DEPARTMENT OF TRANSPORTATION**Federal Aviation Administration****14 CFR Part 36**

[Docket No. FAA-2000-7958; Notice No. 00-11]

Noise Certification Regulations for Helicopters

ACTION: Notice of Proposed Rulemaking (NPRM).

Figure H1.
Comparison of Measured and Reference Takeoff Profiles

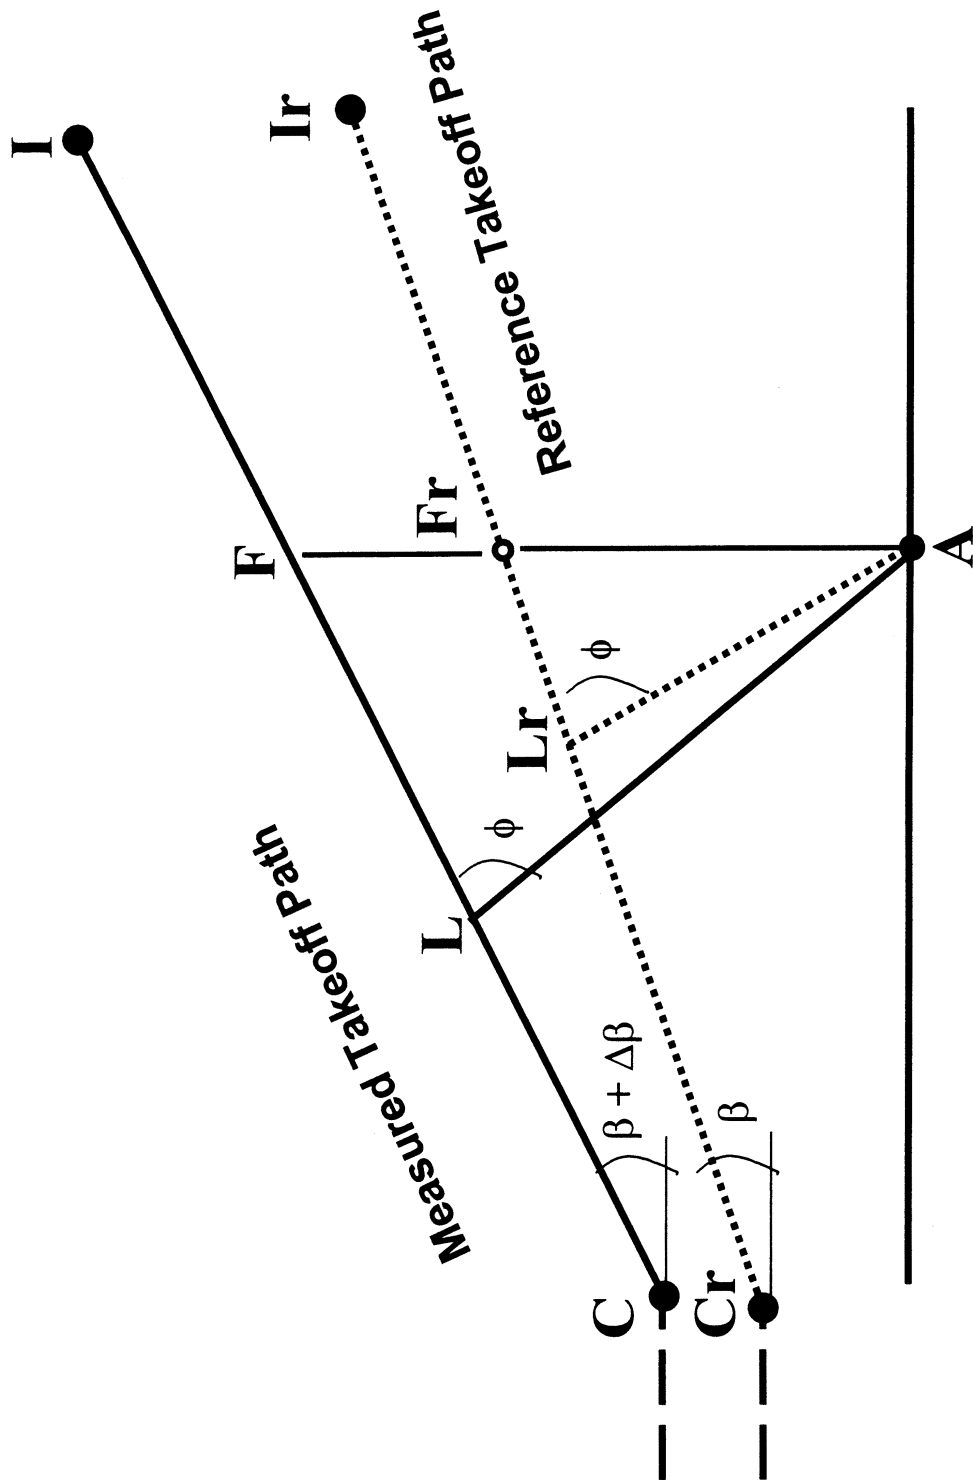
Proposed revision to Figure H1 deletes the designation of Positions Tr since the minimal distance designation is no longer needed and includes the height above measurement point in metric units; see the text of proposed section H36.205(b)(3) regarding the takeoff condition.

In proposed Figures H1, H2, and H3 the titles of the figures are changed to reflect the language of this proposal. The word "reference" would replace the word "corrected" in each title.

Figure H2.
Comparison of Measured and Reference Flyover Profiles

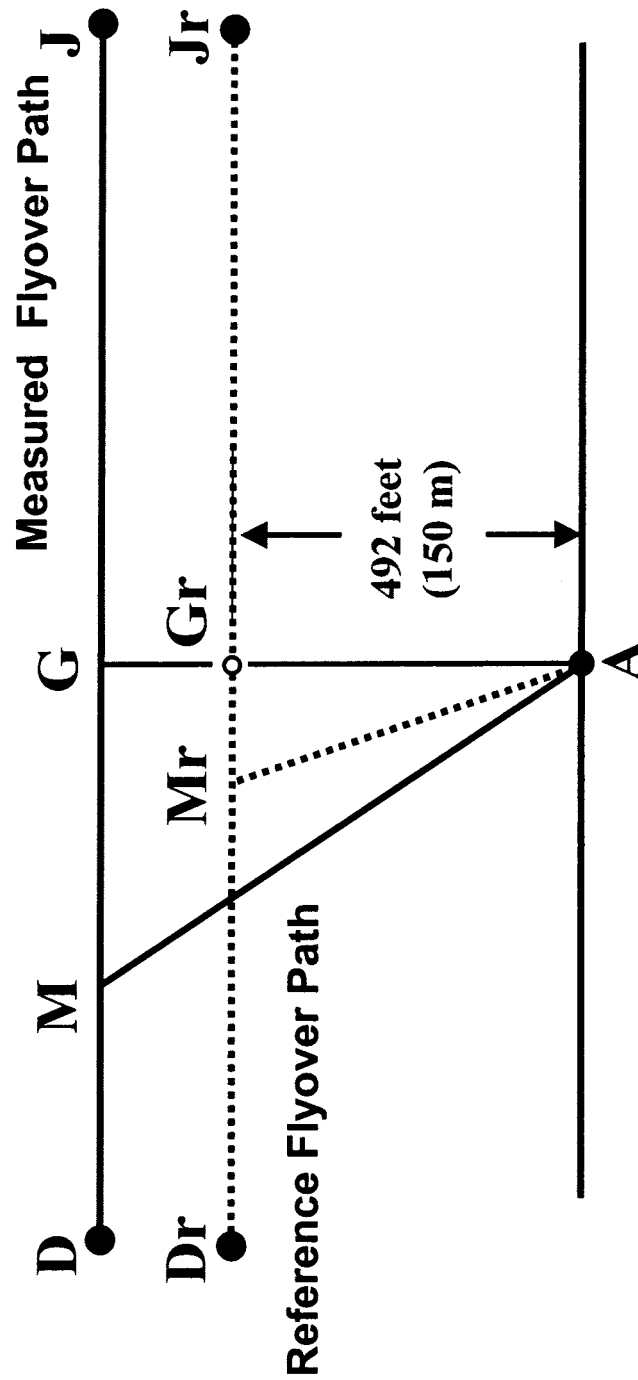
Proposed revision to Figure H2 repositions the bullet-marker that's incorrectly positioned near label G due to a typographical error. The marker is repositioned in the proposed revised graphic image at the intersection of line Dr–Jr and line A–G.

Figure H3.
Comparison of Measured and Reference Approach Profiles

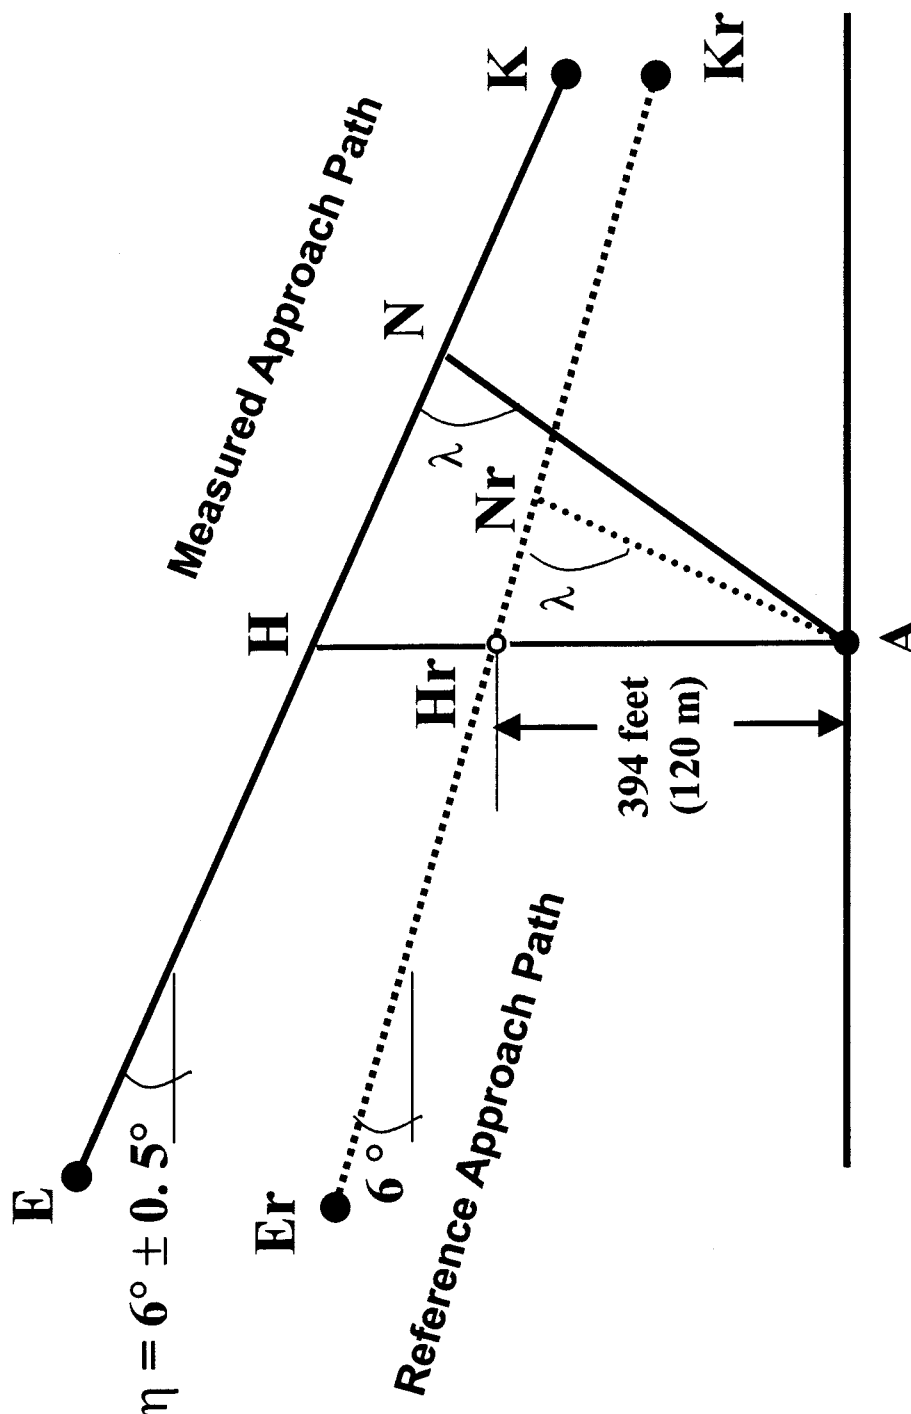
Proposed revision to Figure H3 deletes the designations of Positions S and Sr since the minimal distance designation is no longer needed and includes the height above measurement point in metric units; see the text of section H36.205(d)(3) regarding the approach condition.
